One (1) copy of revision to Source Control Drawing 10-81000 "Dyna-Soar Ejection Seat and Survival System" dated March 16, 1962 (Unclassified)

SYM	DESCRIPTION	DATE	APPROVAL
D	<p>(1) Changed seat back boost position angle from 3 degrees aft to 2 degrees forward and called for adjustable upper arm supports to conform. (2) Revised sled test requirements to call out specific responsibilities and requirements, including heat shield in Appendix B. (3) Made The Boeing Company responsible for the lower half of the tube-cutter electrical disconnect and the pressure switch tube disconnect. (4) Called out rail hole size and rail end chamfer. (5) Called for safety pin in harness release handle. (6) Clarified "D" ring position in Figure 8.</p> <p>Reason: (1) Customer requested new seat back angle for boost. (2) through (6) Completion of basic design and drawing clarification. BO-2-0046</p>	<p>1/16/62</p>	<p><i>[Signature]</i></p> <p>Done 8-19 Feb 3/16/62</p>

DYNA-SOAR
EJECTION SEAT AND SURVIVAL SYSTEM

10-81000

BUKING NO. 2-81000
PAGE 23

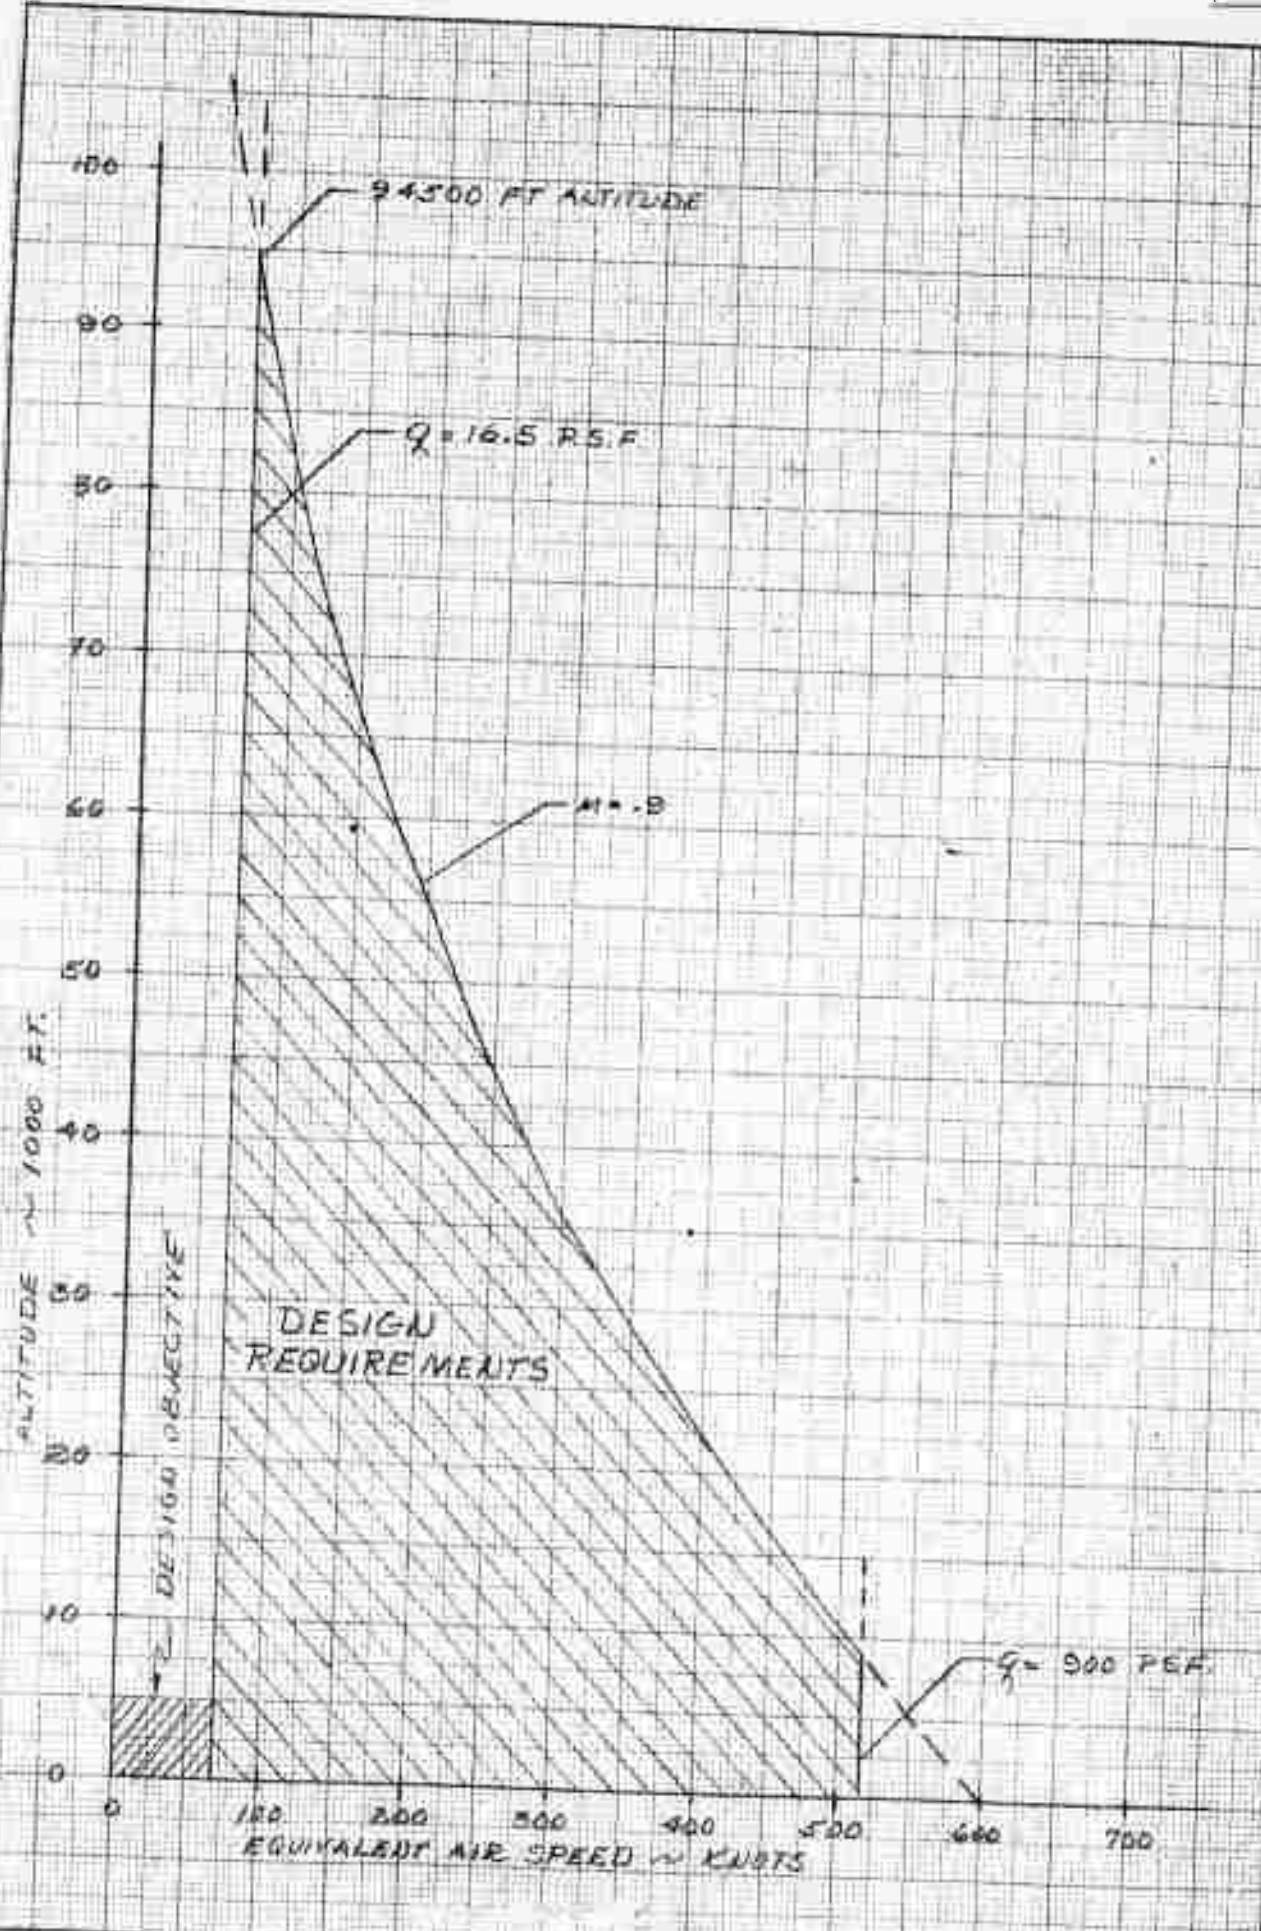
3.2.1 SEAT ADJUSTMENT. The seat shall be designed to provide vertical adjustment and seat back tilt adjustment. Vertical adjustment of the seat will not be required in flight, but will be a preflight operation on the ground. R
↓

3.2.1.2 SEAT BACK TILT ADJUSTMENT. The seat back shall be designed to provide manual seat back tilt positioning. The seat positioning lever or control shall be located on the top of the left hand side panel in a convenient and readily accessible position to the pilot or ground crew. Seat back tilt shall provide two positions with stops, namely; "Boost" position 2° forward of normal vertical, and "Ejection" position 13° aft of normal vertical, as shown in Figure 1. The flight position may be selected anyplace between the two positions at the pilot's option.

For the ejection sequence, the seat back shall be automatically power actuated to the ejection position and locked in place by a ballistic powered actuator or similar device. Electric powered actuators or devices shall not be used. This function shall be included in the seat pre-ejection sequence. Automatic seat back positioning may be incorporated into inertia reel design (paragraph 3.2.6) eliminating the need for a separate seat back positioning actuator. Positioning of seat back to the ejection position under forward accelerations (eyeballs in) shall not result in pilot injury of any kind. Failure of automatic pre-ejection seat positioning shall not prevent seat ejection. (See Figure 2.) R

3.2.10.1 UPPER ARM SUPPORT. Arm supports shall be provided on each side of the ejection seat back to provide maximum support to the upper arms of the pilot during boost. The arm supports must clear the 28 inch hatch envelope although they may exceed the nominal 25 inch ejection envelope. The arm supports shall be adjustable for 1.00 inch forward and one inch aft at the nominal position. The adjustment shall be designed such that the top and bottom ends may be moved throughout the adjustment either jointly or separately. See Figure 1, page 23.
